Access Compliance Report

Public Rights-of-Way

Intersection ID: N/A	Main Street: HUNTERS_CROSSING_LN	Cross Street: THE_PLAZA	Location: SW
ADA ID: 3B5E12E5ED22	Ramp Type: Combination2Diag	Initial Pass/Fail: Fail	Overall Compliance: No
		Severity Score: 0

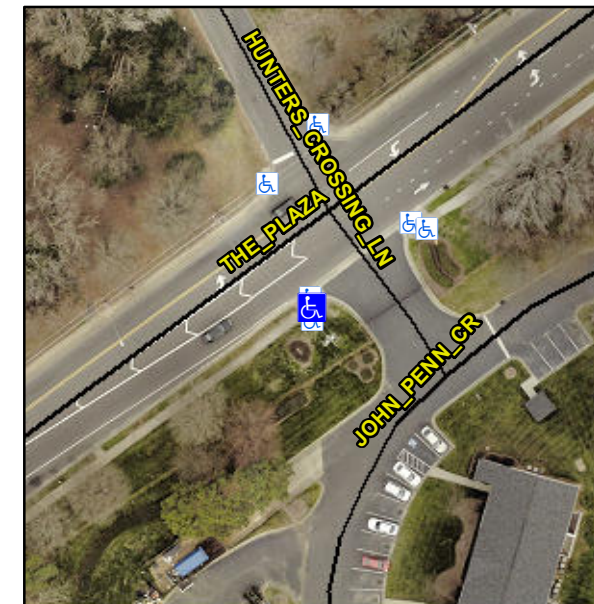
Not Found, R304.5.1, R304.5.3

Compliance	Description	Data	Compliance	Description	Data
N/A	Ramp Length LT (in)	30.0	N/A	Ramp Length RT (in)	45.5
Yes	Ramp Width LT (in)	54.5	Yes	Ramp Width RT (in)	61.0
Yes	Ramp Slope LT (%)	4.2	Yes	Ramp Slope RT (%)	5.2
No	Ramp XSlope LT (%)	2.7	Yes	Ramp XSlope RT (%)	0.6
N/A	Ramp Length (in)	48.0	Yes	Ramp Slope (%)	2.5
No	Ramp Width (in)	47.0	Yes	Ramp XSlope (%)	1.3
N/A	Flare Type LT	N/A	N/A	Flare Type RT	N/A
N/A	Flare Slope LT (%)	N/A	N/A	Flare Slope RT (%)	N/A
N/A	Flare Traversable LT?	N/A	N/A	Flare Traversable RT?	N/A
N/A	Landing Length (in)	N/A	N/A	DWS Provided?	N/A
N/A	Landing Width (in)	N/A	N/A	DWS Contrast?	N/A
N/A	Landing Slope (%)	N/A	N/A	DWS Length (in)	N/A
N/A	Landing X Slope (%)	N/A	N/A	DWS Full Width?	N/A
N/A	Landing Curb? (Y/N)	N/A	N/A	DWS Offset (in)	N/A
N/A	Shared Landing?	N/A			
N/A	Gutter Ponding?	N/A	N/A	Gutter Slope (%)	N/A
N/A	Gutter Lip Ht (in)	N/A	N/A	Gutter X Slope (%)	N/A
N/A	Painted X Walk1?	No	N/A	Painted X Walk2?	No

Remove & Replace Curb Ramp With Two New Directional Ramps or Equivalent.
